STAFF REPORT

To: Planning Board – for Regular Meeting on May 4, 2026
From: Kim Golden, P.E., City Engineer 
CC: Doug Kneupper, P.E., Consulting Engineer
Date: April 28, 2026
Re: Marlow Lake, Section 6 – Preliminary Plat

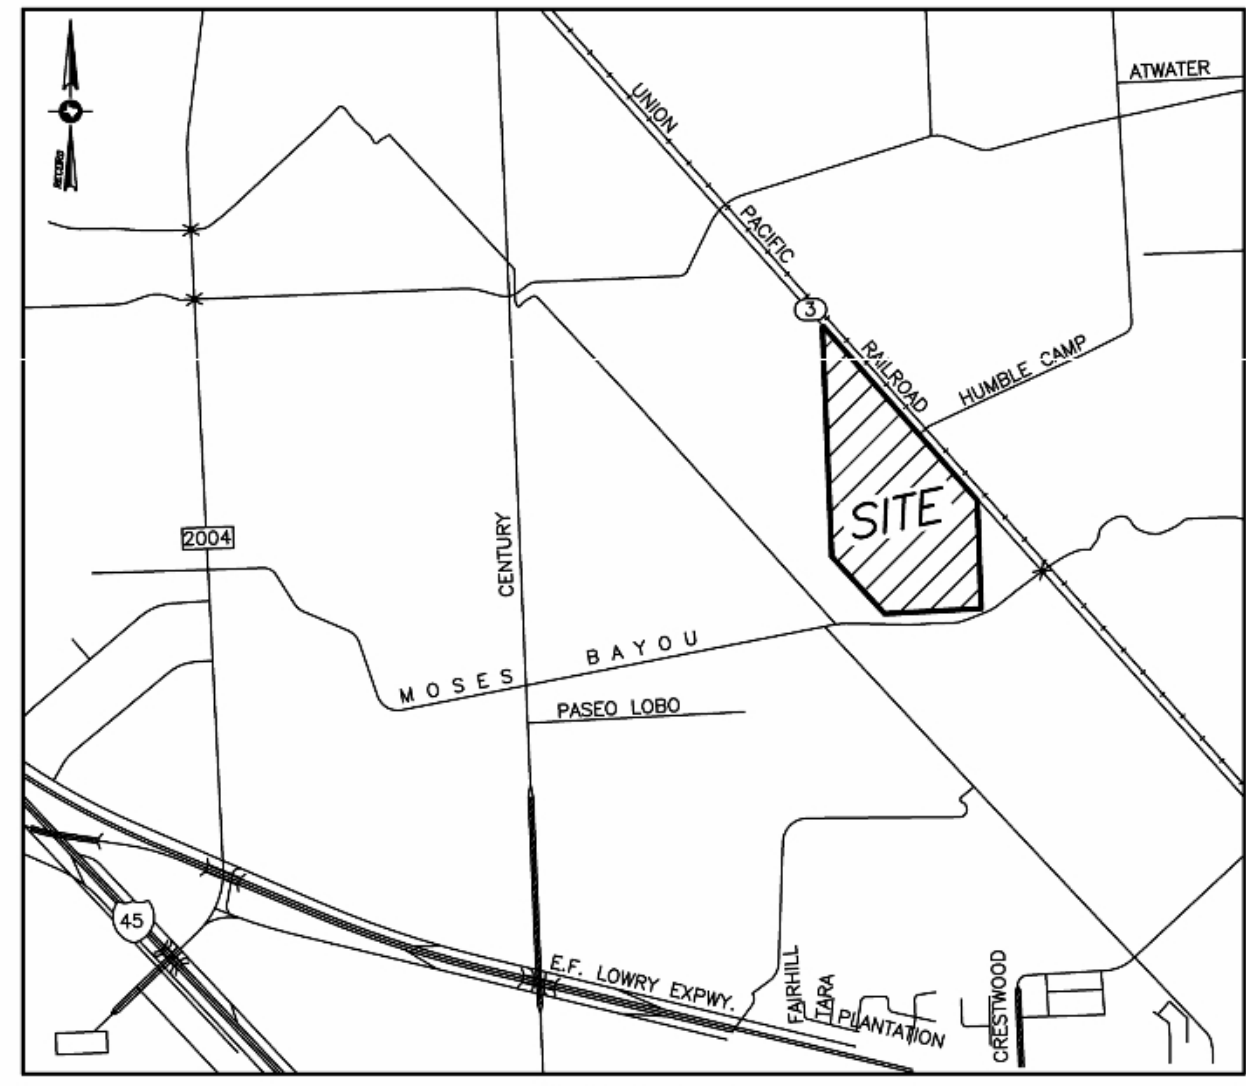
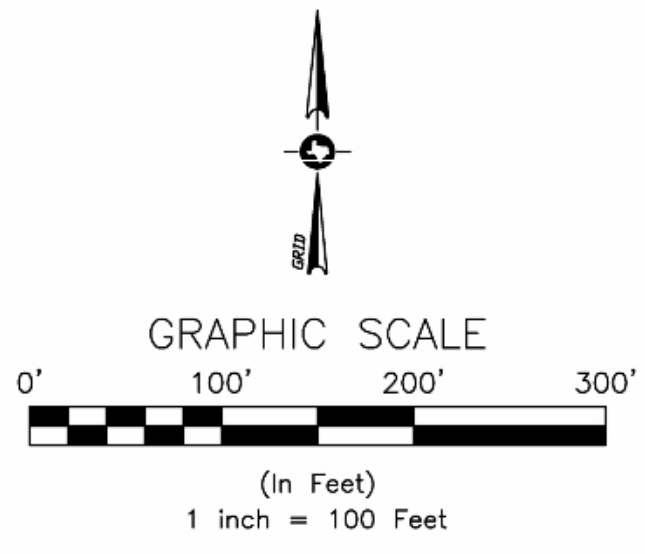
an amenity lake. It is also noted Reserve "B" along the west boundary is encumbered with a pre-existing pipeline easement to which the 25ft setback requirement of 160.091(H) will apply. Preliminary "one-line" construction drawings showing the locations of utility lines, drainage, and the street patterns, have been reviewed and approved. GCDD No. 2 has provided conditional approval of the drainage plan subject to receiving signed and sealed final construction drawings.

The Preliminary Plat should follow the master plan with regard to arrangement of lots, layout and alignment of streets, parks, and open spaces. The Preliminary Plat for Marlow Lake Section 6 does generally conform to the arrangement provided for Marlow Lake North.

Staff have reviewed the Preliminary Plat for Marlow Lake Section 6 and offer no objection to approval. **Staff recommend approval be conditioned upon the continued submittal of updates showing progress toward a final plan and schedule for construction of the amenities around the lake and along SH3.**
